MEMORANDUM

Subject: Bank of America Appeal/Findings and Conclusions

A RESOLUTION OF THE CITY COUNCIL OF THE CITY OF KIRKLAND ADOPTING FINDINGS AND CONCLUSIONS AND REVERSING THE DECISION OF THE DESIGN REVIEW BOARD GRANTING DESIGN REVIEW APPROVAL TO THE BANK OF AMERICA/MERRILL GARDENS MIXED USE PROJECT AT 101 KIRKLAND AVENUE. (FILE NO.: DRC 07-0006; APPEAL CASE NO.: APL08-0001)

Re: Comments and Suggested Revision regarding Proposed
Findings and Conclusions
Appeal Case No. APL08-00001; DRC 07-00006

CAFE - PREVIOUS

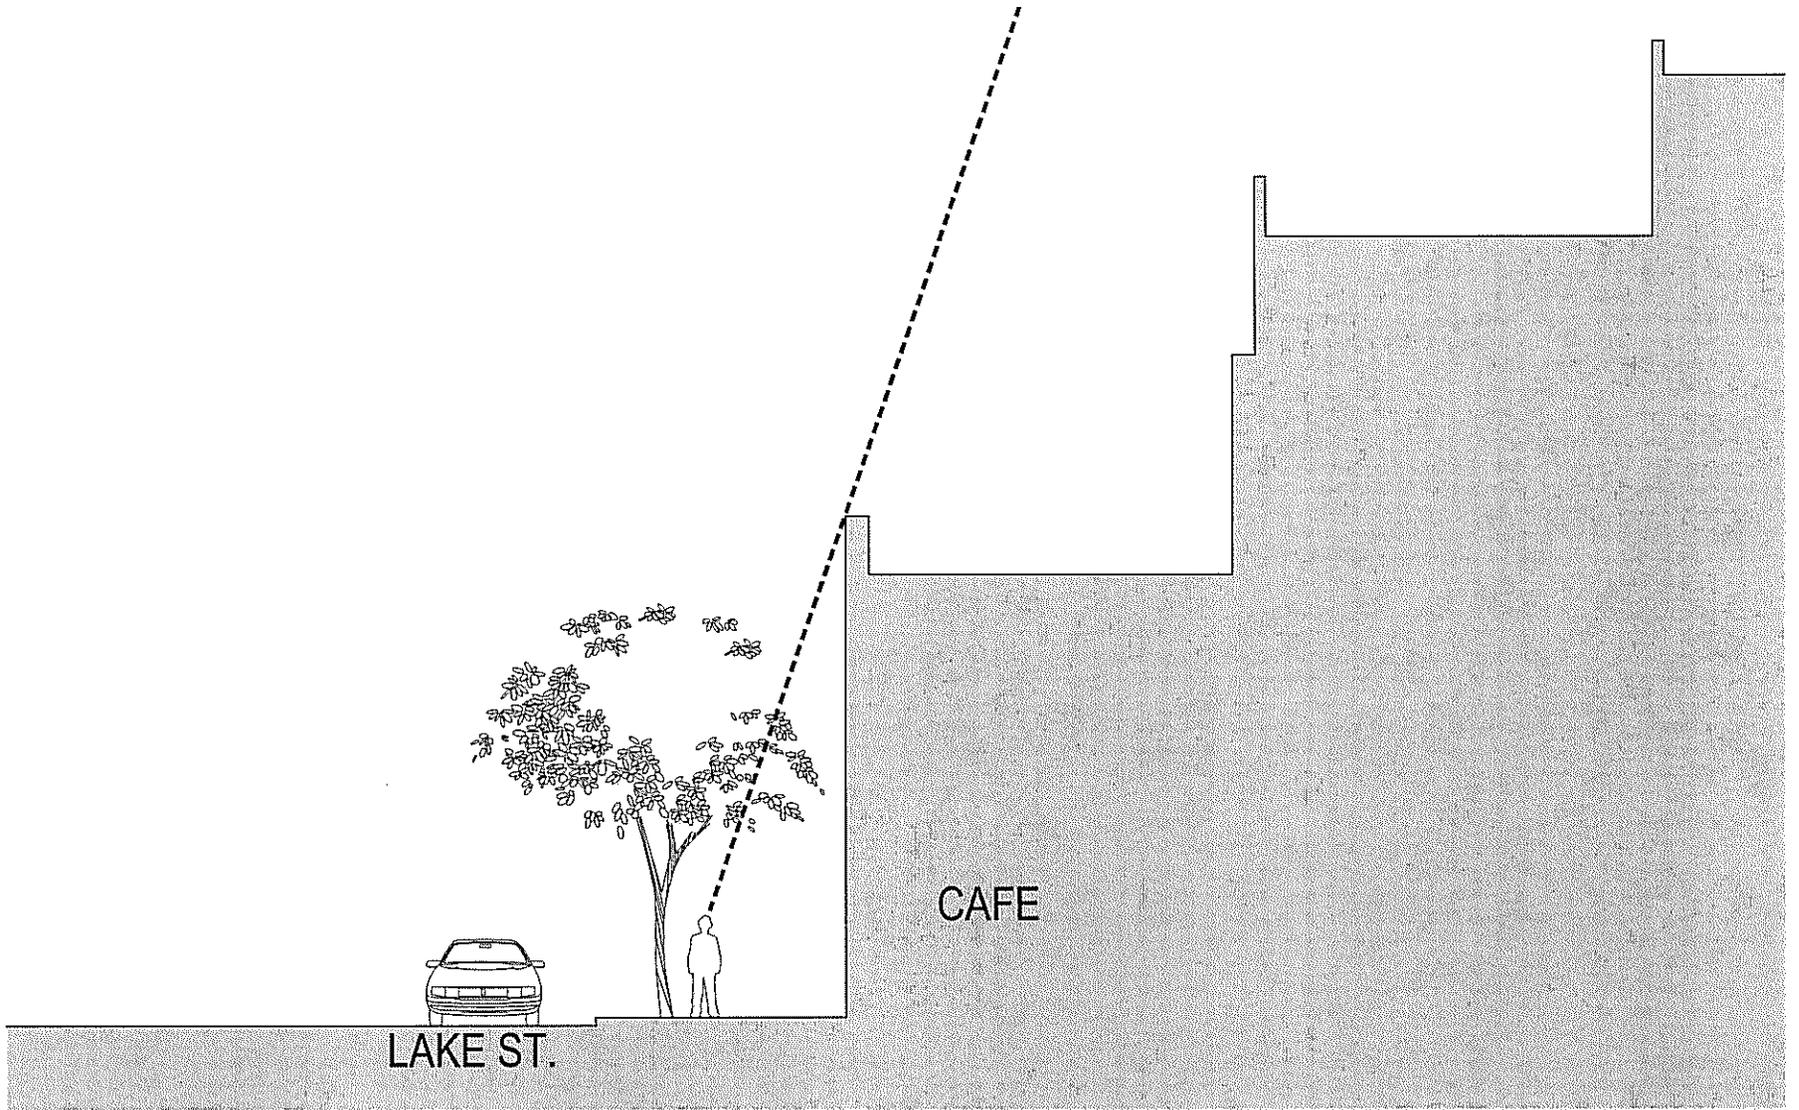
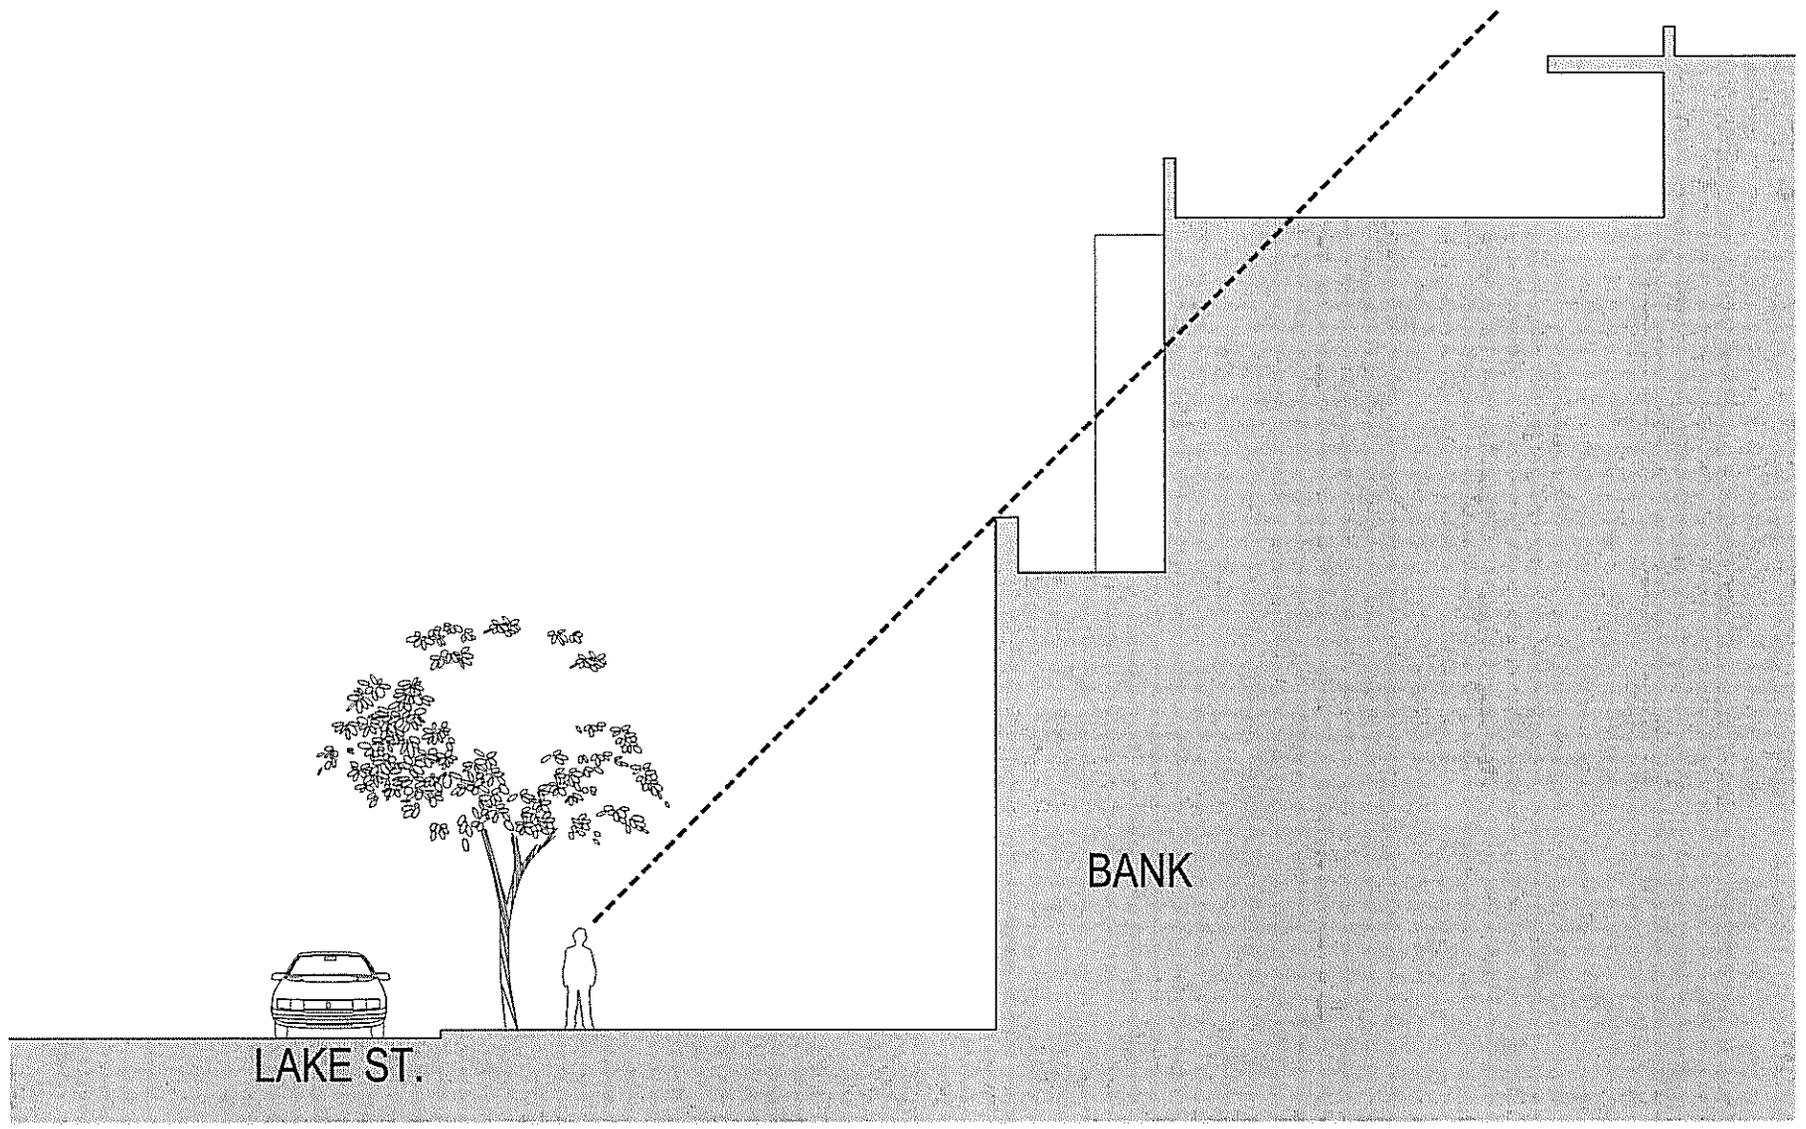
With regard to the "superior retail space" criteria, SRM lacks adequate direction from the Council to prepare similar revised drawings for the project. However, we believe that we can address one of the key concerns and misconceptions regarding the corner space – that it was designed as a bank. We have prepared a drawing showing how the corner space as currently designed could also be utilized as a restaurant. As explained in greater detail in the attachment, the corner space was never "designed as a bank." Instead, it was designed as an approximately 5,700 square foot retail space consistent with the joint DRB/staff created criteria for evaluating "superior retail spaces." It could be utilized by any number of different types of retail uses. If the majority of the Council continues to believe that this space does not meet its interpretation of the "superior retail space" criteria, SRM requests clarification from the Council regarding what is necessary for this space to meet the criteria, and an opportunity to revise the project to better conform to that direction. Absent such clear direction, SRM is left to guess at the Council's meaning.

LEVEL L2 - REVISED

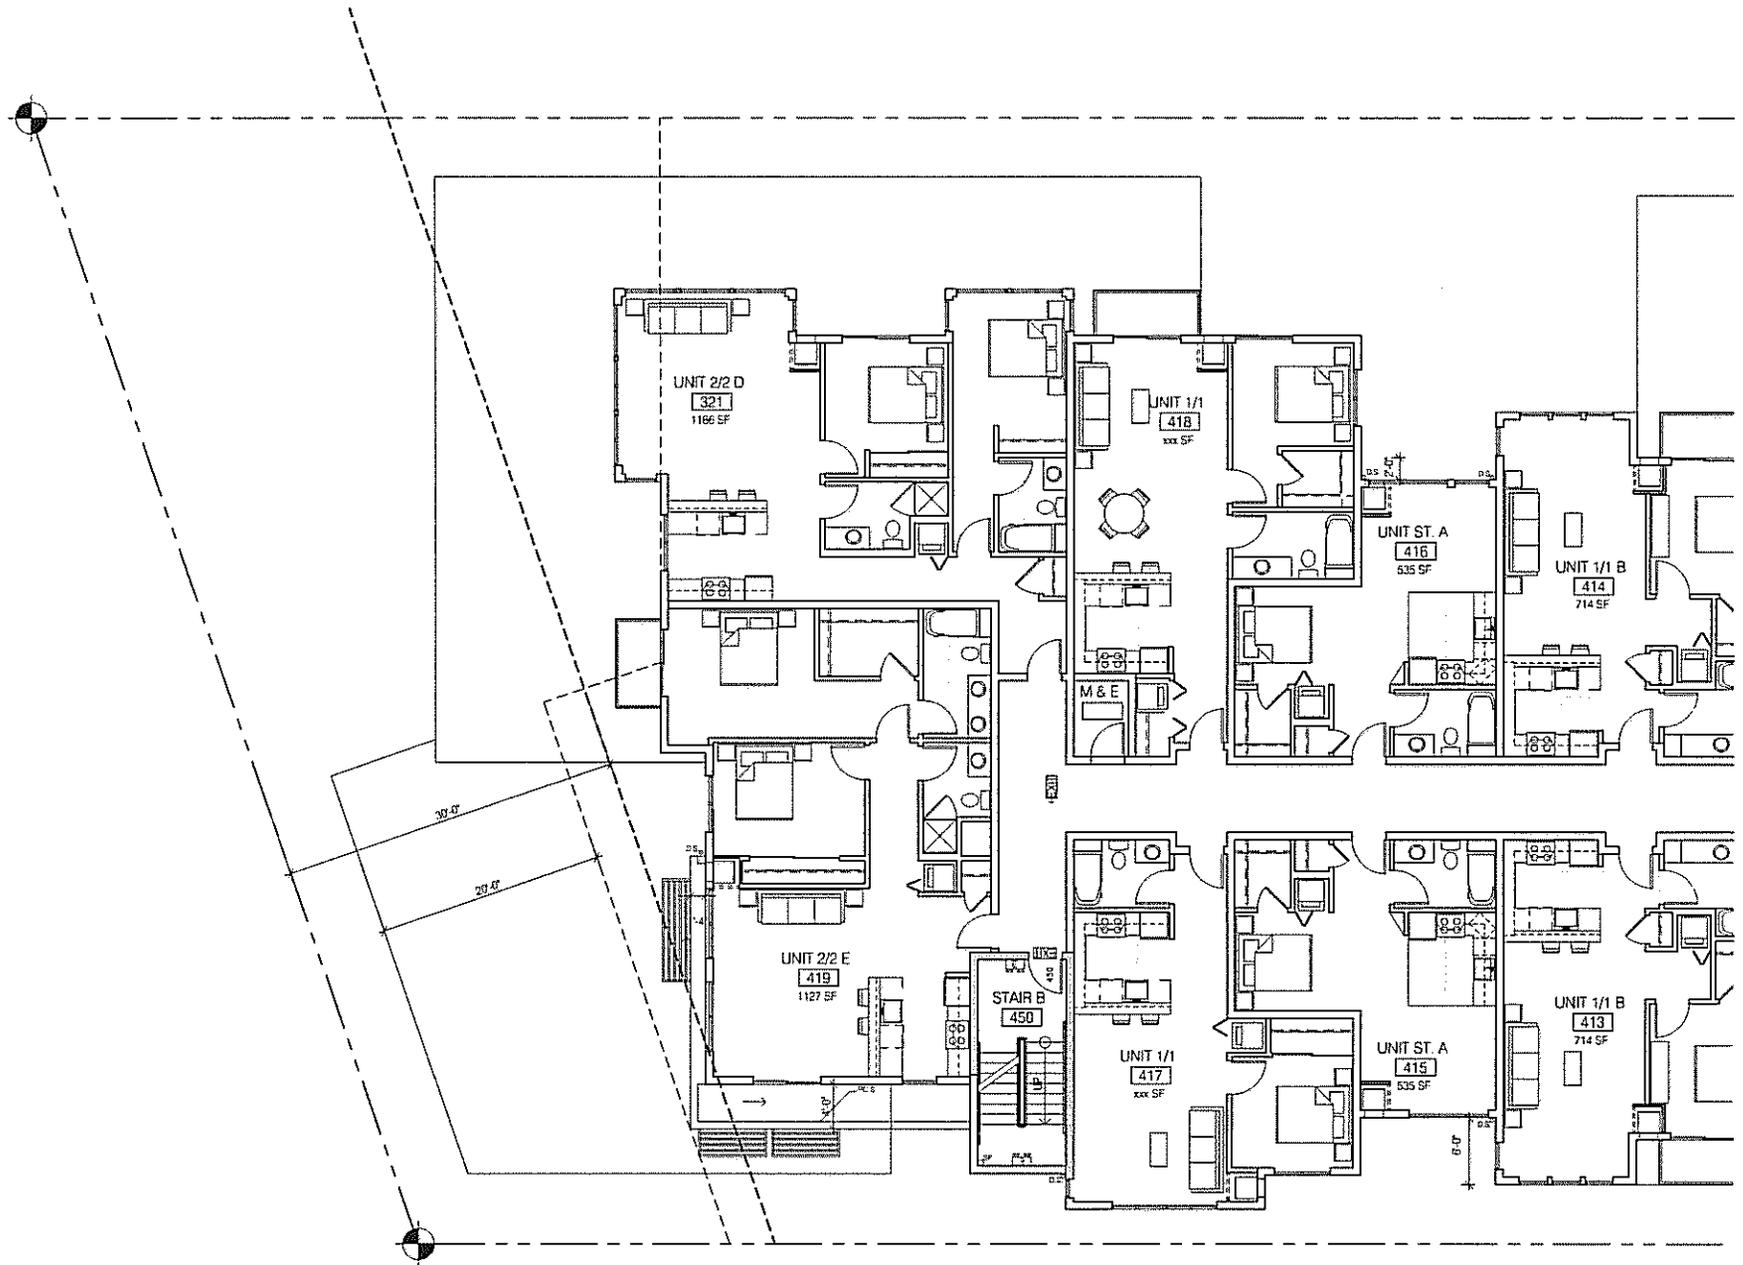
As part of its comments on the Findings and Conclusions, SRM has proposed modifying the Council's decision from a reversal of the DRB's approval of the BOA/Merrill Gardens project to an approval of the project as modified. As the Council acknowledged during its May 20th meeting, you have authority to consider modifications under the Kirkland Code. KZC 142.40(11)(b)(3). To facilitate this discussion, SRM has included revised renderings of the project showing increased setbacks between the second and third stories and between the fourth and fifth stories along Lake Street South. We believe that this revised design should resolve any

outstanding questions or concerns regarding the building's compliance with the Lake Street height restrictions. We offer this design as an alternative for your review and approval as a modified design.
